EDDY & MASON

4/21/21

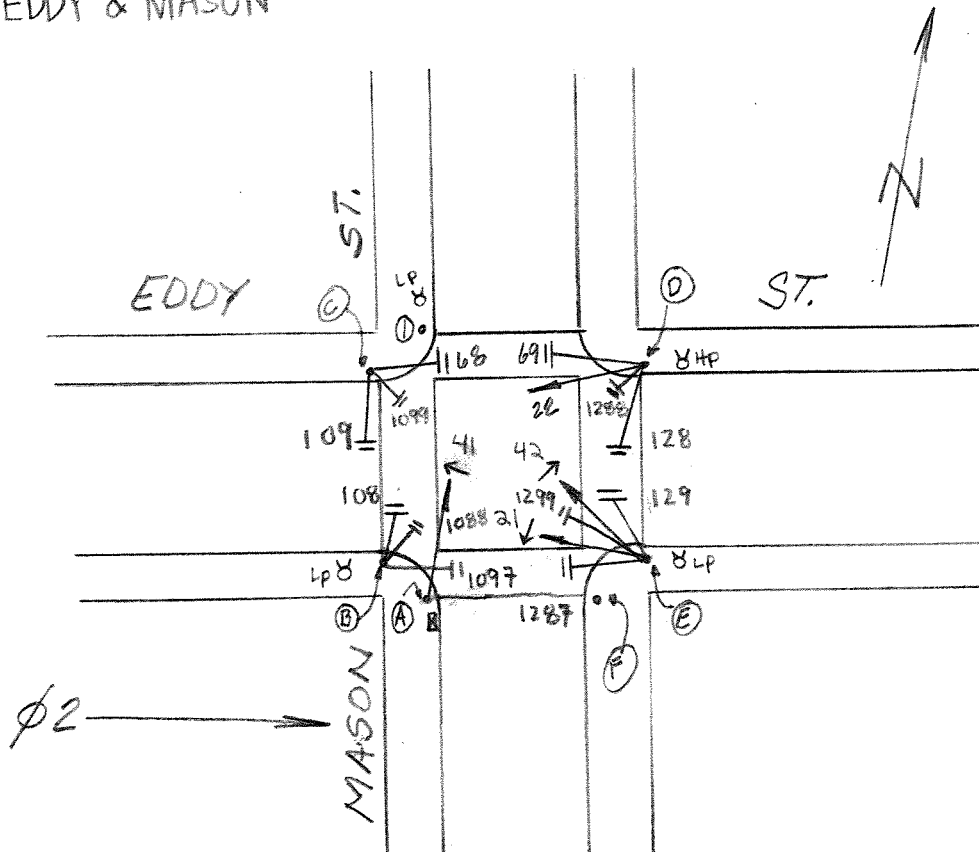
COMMENTS: Add Diagonal Ped Signals. Relocate 29 to pole "B" and renumber to 1097. Change 41 to 45 12" GRA. Renumber phase 8 to 12, and 4 to 10. Renumber 28 to 1287. PER SRC 2021-046. D.YEUNG 4-21-21
